Access Compliance Report

Public Rights-of-Way

Intersection ID: 14431	Main Street: N_COLONIAL_AV	Cross Street: RANDOLPH_RD	Location: NE
ADA ID: 11AA33A4DD04	Ramp Type: Perp	Initial Pass/Fail: Pass	Overall Compliance: No
Severity Score: 7.5			
Codes/Mitigation Info/Possible Solution		Field Measurements/Component Compliance

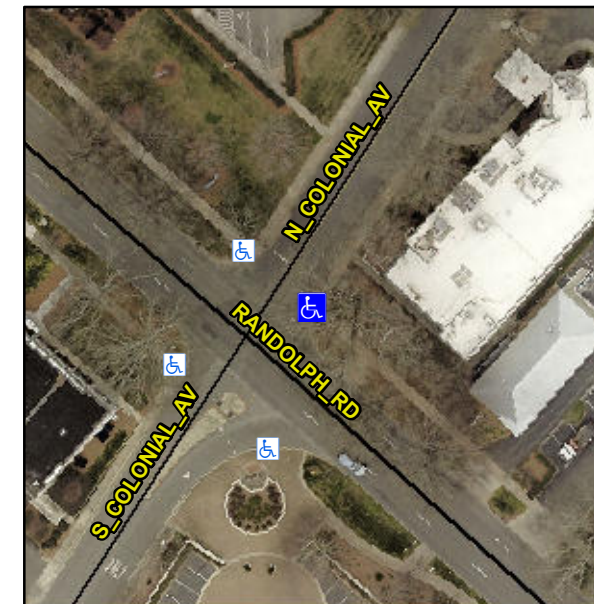
**Remove & Replace Entire Ramp.
Remove & Replace Gutter.**

**Not Found, R305.1.4, R305.2,
R304.5.4, R304.5.3**
